April 20,2017

Module devices AMW006 and AMW106 from Silicon Labs have been shipped using 2 different marking label orientations. This may create confusion when trying to identify the pin 1 during orientation of the module and possible misorientation of the modules during surface mount.

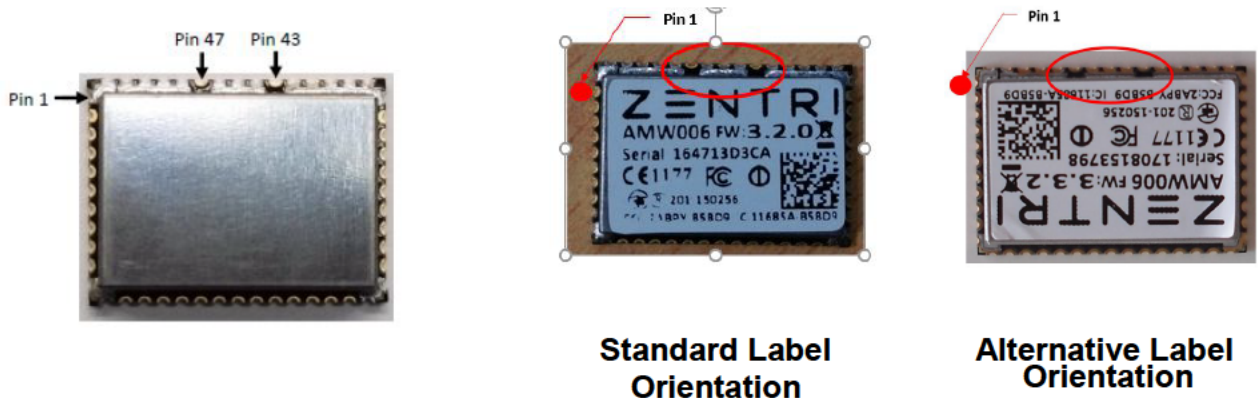
There are two possible label orientations as described below. The location of pin 1 should always be determined by the antenna pins 47 and 43 which show as notches in surrounding soldered ground pins.

All shipments after 20 April 2017 will carry the Standard Label Orientation to help avoid any confusion in the future.
